30-045-34565 HUERFANO UNIT #306

CROSS TIMBERS ENERGY, LLC

Cross Timbers Energy, LLC intends to P&A the Huerfano Unit 306. Procedure below

BLM FLUID MINERALS Geologic Report

2) Hilcorp Energy Co. Water Analysis
Huerfano Unit # 172
1720' FNL, 1090' FWL
Sec 9, T25N, R9W
GL 6689', KB 6702'

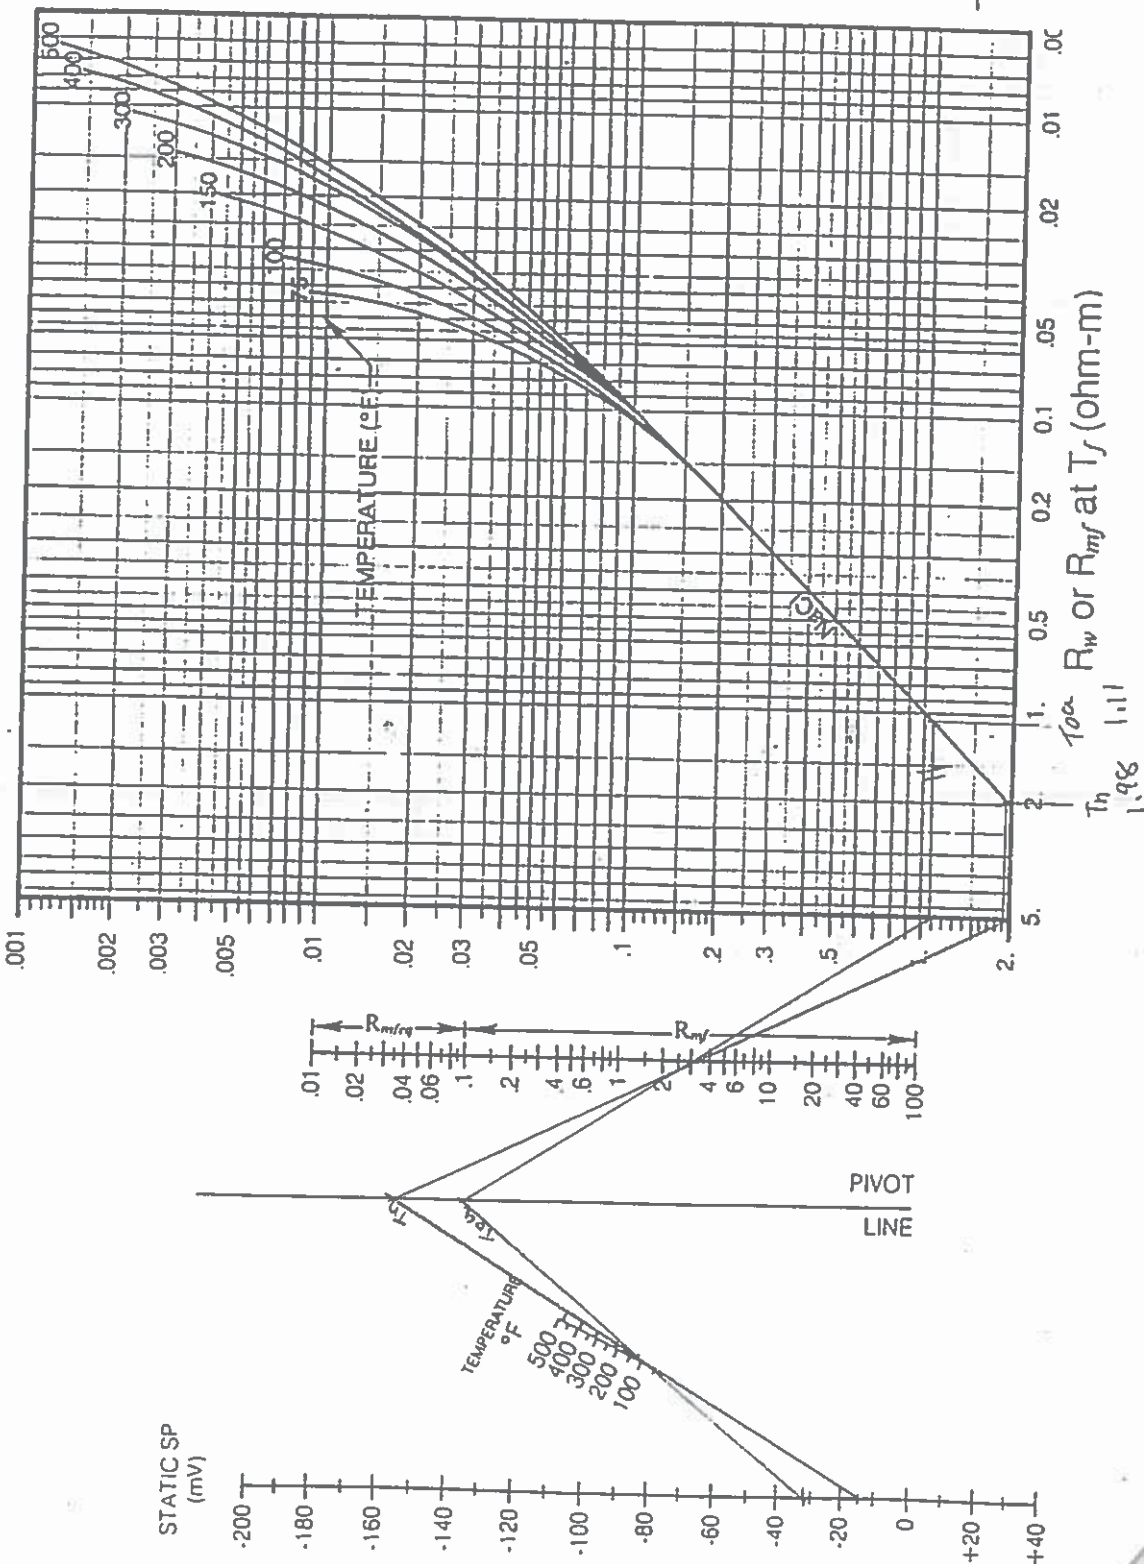
- Log analysis of reference well #2 (attached worksheet) indicates the Ojo Alamo and Nacimiento Formations contain fresh water ($\leq 5,000$ ppm TDS).
